Proposal how to structure the RESS safety requirements

12-14 April 2011 RESS-4-8

- Red = RESS-3-7 Vibration Draft JP Proposal
+ Further comment (in dotted box) / proposal (with yellow marker)
- Green = Remarks or amendments by the secretary
- Purple = Remarks from TÜV and BMW under § 3.7
- Blue = Remarks from France
- Turquoise = Comments and proposals from Sweden

Diagram 1 – minimum shock pulse

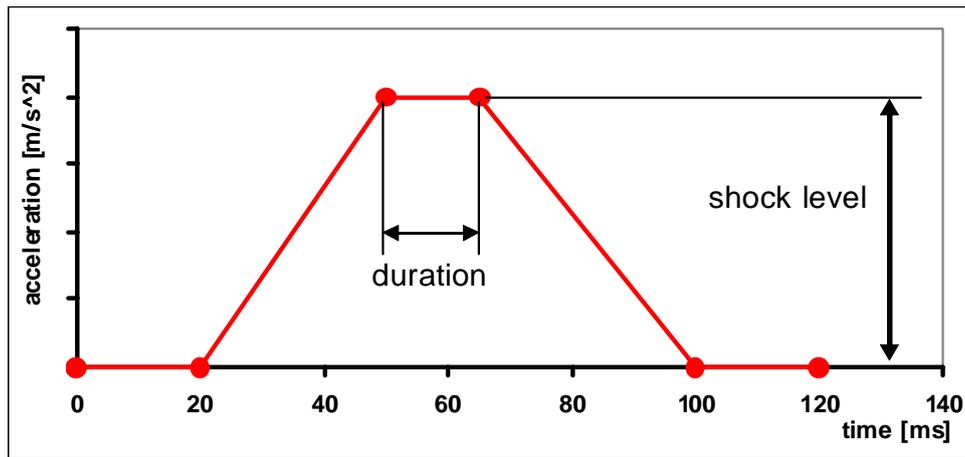
Comment (Sweden) regarding the acceleration pulse found in R17 and R44

The upper limit of the acceleration pulse found in R17 and R44 is exceeded in the R94 crash simulations presented by VDA in the FIMCAR project. Modern vehicles represents higher structural stiffness and consequently also higher acceleration peaks than the vehicles on which the acceleration pulse corridor in R17 where designed for. The European Commission has asked for modifications of this pulse to better represent modern vehicles:

Diagram 2 – sinus shock pulse

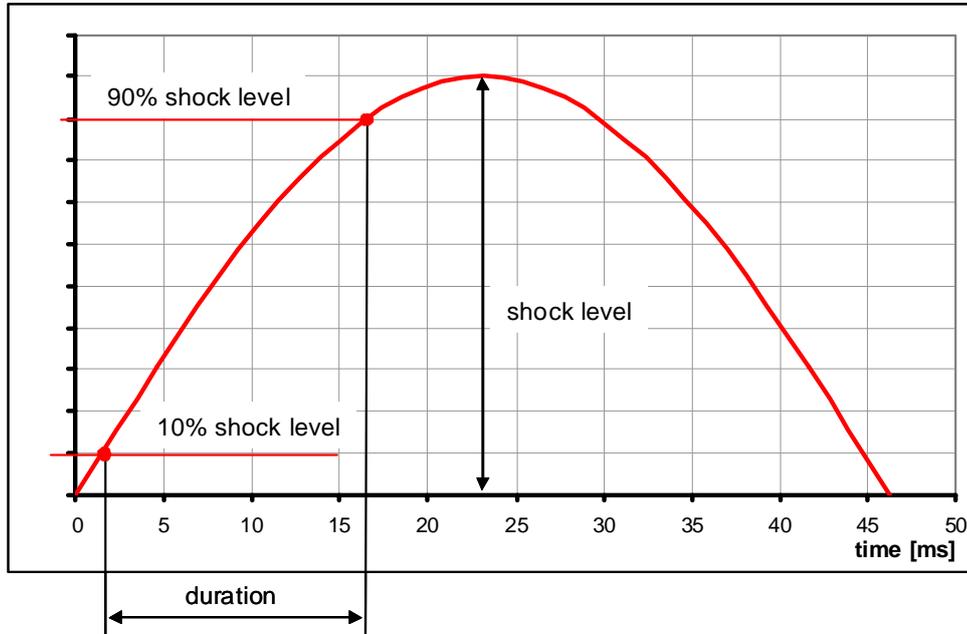
Comment (Sweden) regarding acceleration pulses a) and b)>
Acceleration pulses a) and b) do not represent acceleration pulses equivalent to acceleration pulses generated in a R94 crash test with modern vehicle

<JASIC Comment>
Pulse a) and b) are not considered as equivalent and pulse b) will be difficult to achieve at lower shock level.

Figure 7:

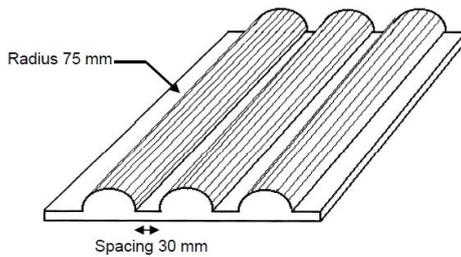
~~To better precise the crush plate position with a drawing.~~
